CP Rail Rogers Pass Development

Glacier National Park

Final Report of
the Environmental
Assessment Panel

August 1983

Figure 10 - The East Camp (Plan)

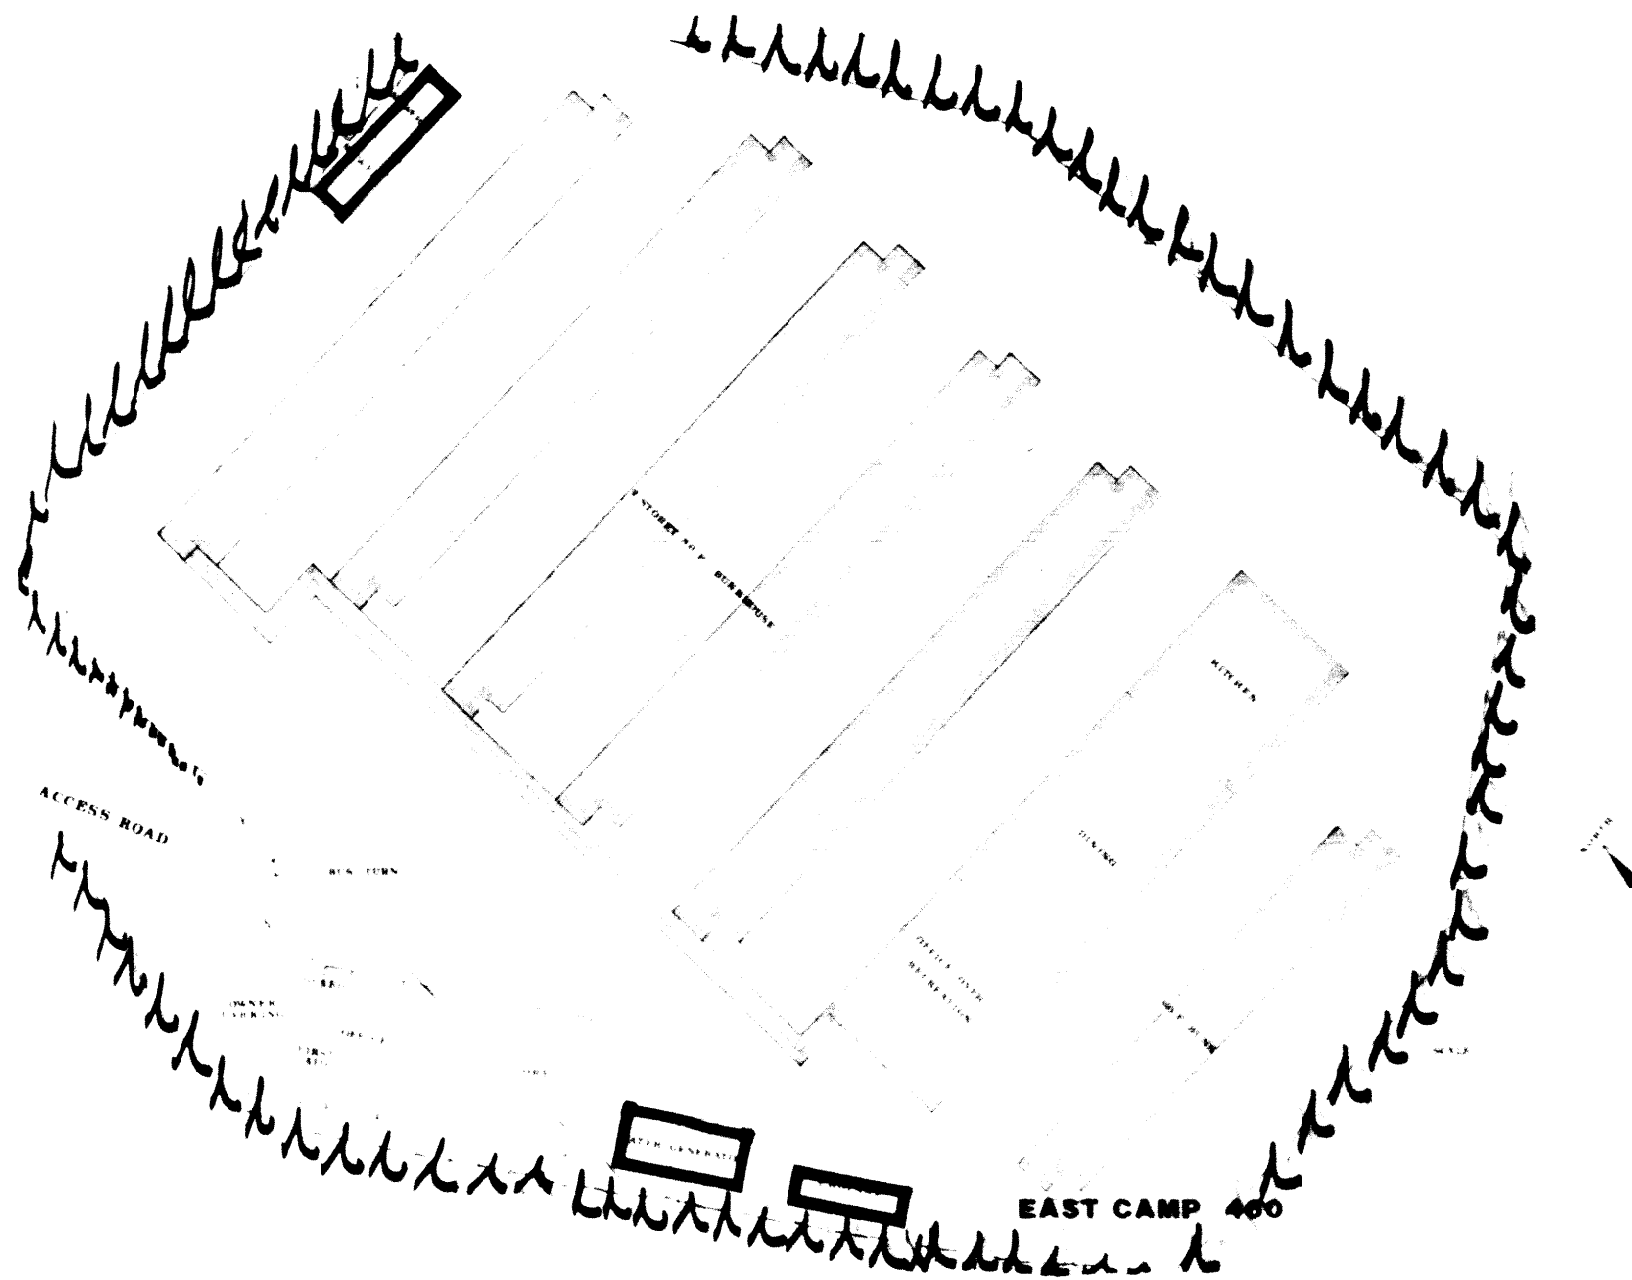
CP Rail has expanded the proposed population of its two main camps from 250 persons each to 420 persons at Flat Creek and 460 persons at Beaver (see Figures 9, 10, 11). A site at Glacier was proposed by CP Rail as an alternative to the Flat Creek camp (Figure 3). The numbers had been revised following CP Rail discussions with tunnel contractors, and visits to projects of similar magnitude. Along with the tunnel and ventilation shaft crews, there would be supervisory staff for the various contractors, and CP Rail's own project staff. CP Rail now intends to operate the camps.

In 1982, Parks Canada was willing to approve CP Rail's work camp proposal. However in 1983, Parks Canada requested CP Rail to withdraw its proposal to locate work camps within Glacier National Park. Among the reasons given were that the camps would be contrary to National Parks policy, contrary to the National Park Plan for Glacier Park, that there would be damaging physical impacts on the Park, that there were no redeeming merits for Glacier National Park, and that alternative sites exist close to but outside the Park boundaries.

Some of the specific concerns identified involved site disturbance outside camp boundaries, displacement of trailheads, aesthetics, social concerns, wildlife conflicts and pollution. A particular concern with regard to the Glacier site related to avalanches. In particular Parks Canada expressed concern about the possibility of clearing beyond the presently disturbed sites and possible future requests from workers for parking areas.

Rotating biological contactors would be installed to meet Environment Canada's wastewater treatment guidelines. The sewage plants would be enclosed within the camps, and effluent would be monitored by the camp maintenance team to ensure adherence to the standards.
